## CCNPP3COLA PEmails

**From:** Lutchenkov, Dimitri [<mailto:dimitri.lutchenkov@unistarnuclear.com>]  
**Sent:** Monday, January 03, 2011 3:39 PM  
**To:** 'Anderson, Kathy NAB02'; 'Francis, Woody NAB02'  
**Cc:** Burkman, Jim; Gibson, Gregory T; Massie, Wayne A; Quinn, Laura  
**Subject:** NMFS Concurrence on Tidal Mitigation Strategy

## MEETING SUMMARY

**Subject:** Tidal Wetland Mitigation; Calvert Cliffs Nuclear Power Plant Unit 3

Figure 1  
Depth Analysis based on MGS 2008 Grab Samples and Side Scan Sonar and EA's 2006 Bathymetric Survey

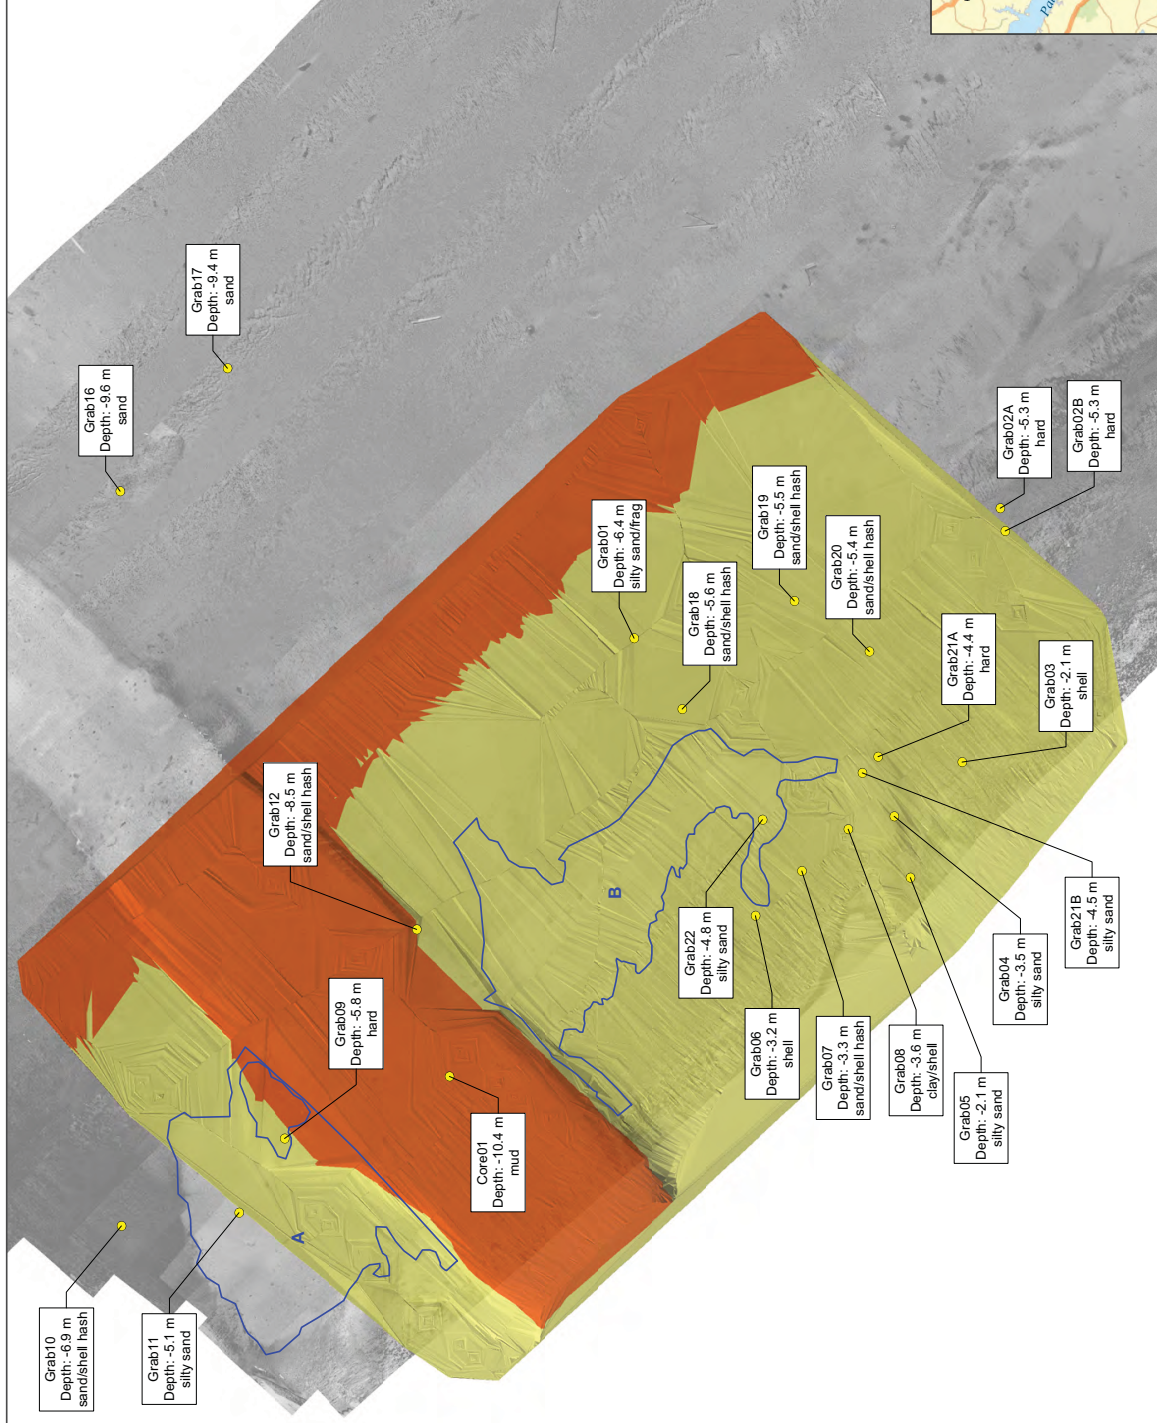
Figure 1 (attached) shows the two areas (A and B) suggested by Mr. Nichols and a depth analysis completed by EA. Ms. McCormick explained that the depth in these areas is currently less than 25 feet, which is the depth at which MGS indicated areas would not be seasonally hypoxic or anoxic (MGS 2008). Ms. McCormick further explained that site bathymetry data (EA 2006) do not indicate any channels or depressions in areas A and B.

Figure 4 – Bottom Types within the Vicinity of the Patuxent River as Identified by MD DNR

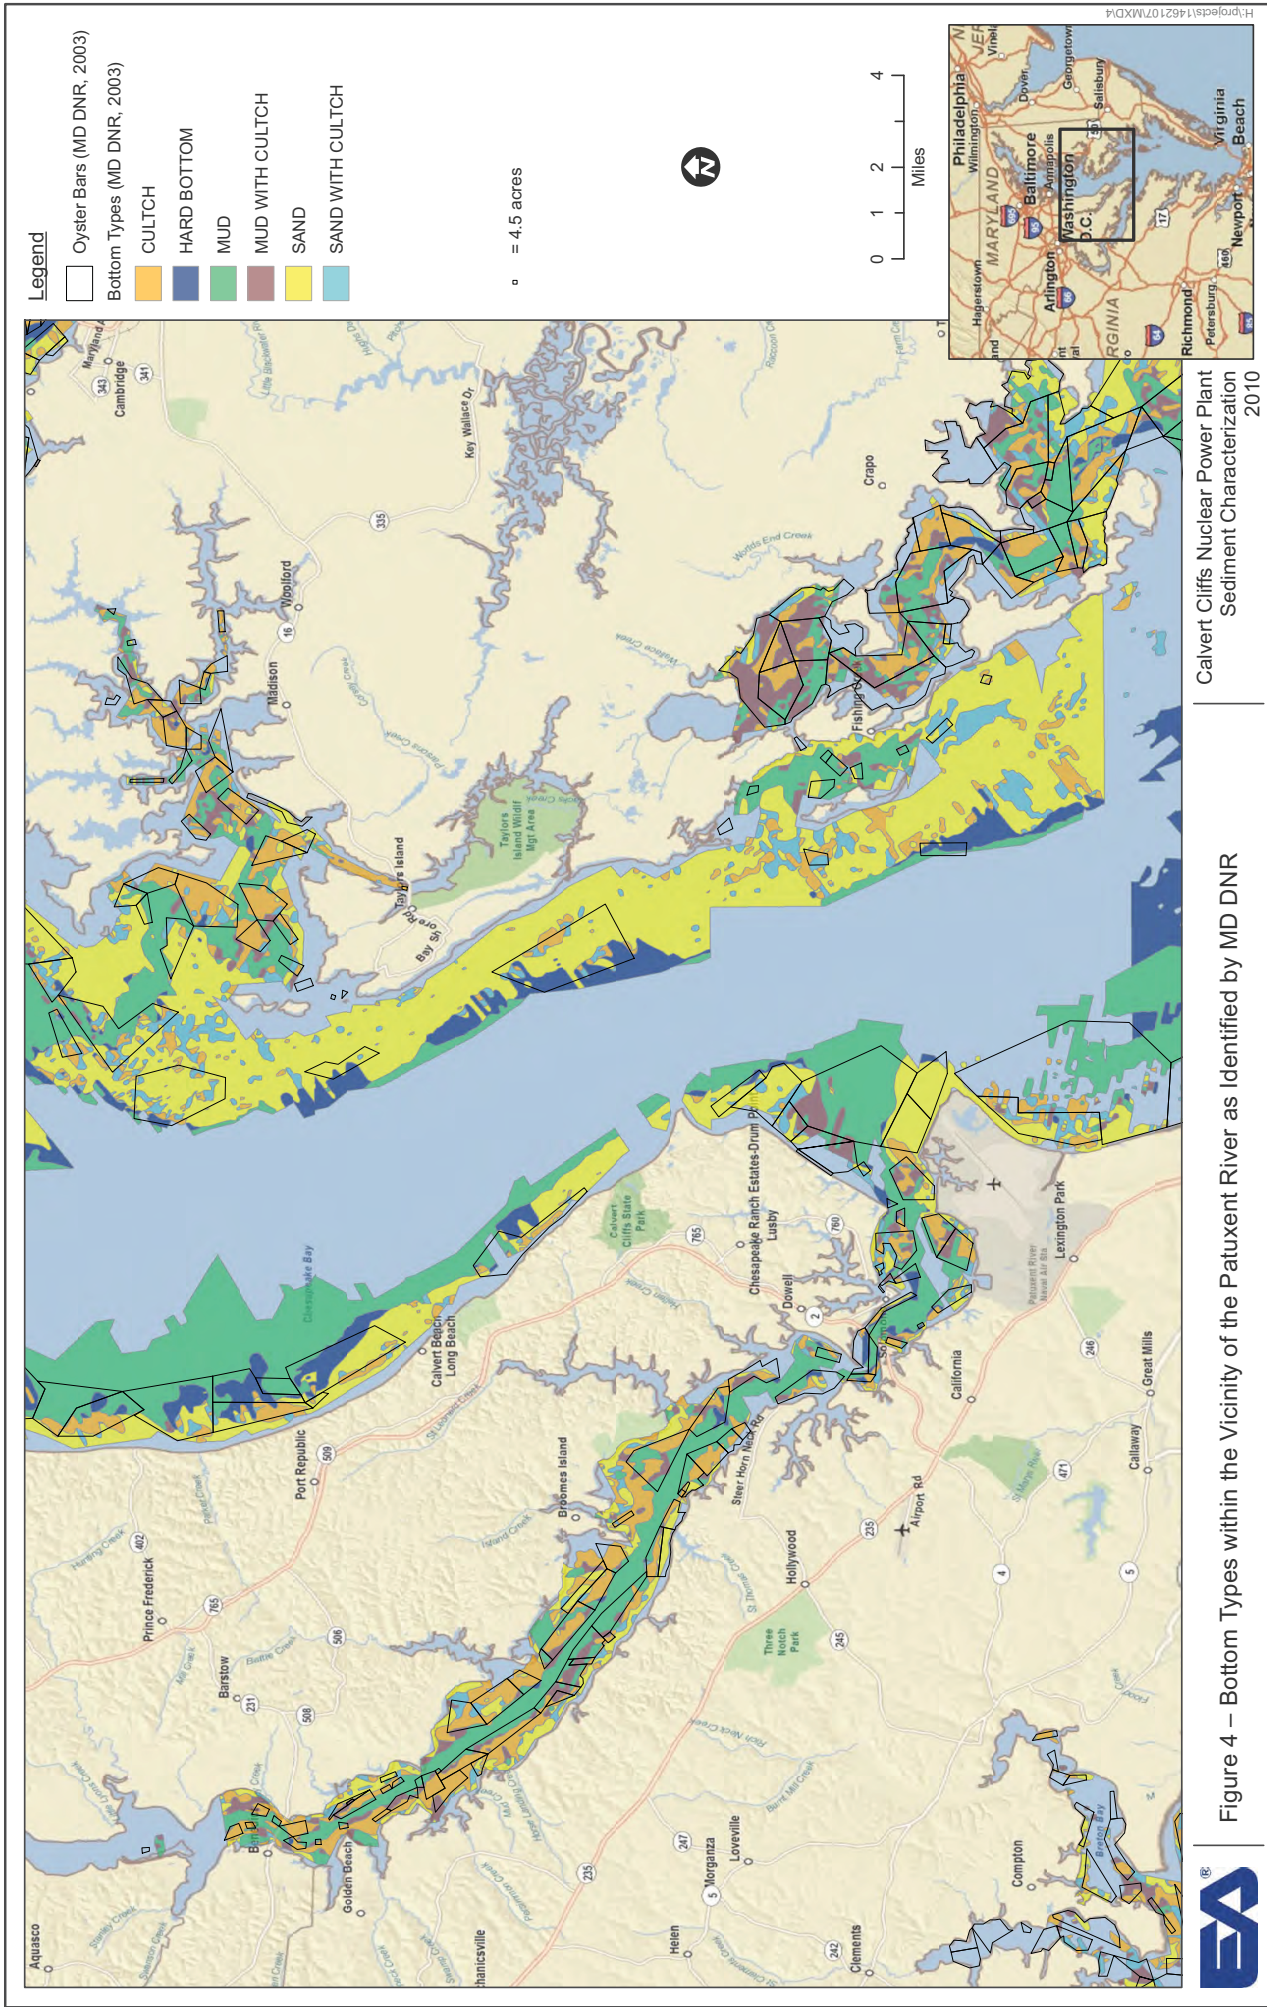
Ms. McCormick explained that UniStar is also willing to look at other sites on oyster bars and had mapped MDNR substrate data over oyster bars in the region, shown on Figure 4 (attached). Ms. McCormick also confirmed that Mr. Nichols would be amenable to work on an area of NOB 19-2 that did not currently have substrate mapping, if sufficient data were collected to verify the suitability of the site. He also noted that if a project was done in shallower areas (<20 ft), then seasonal oxygen studies would not be needed.
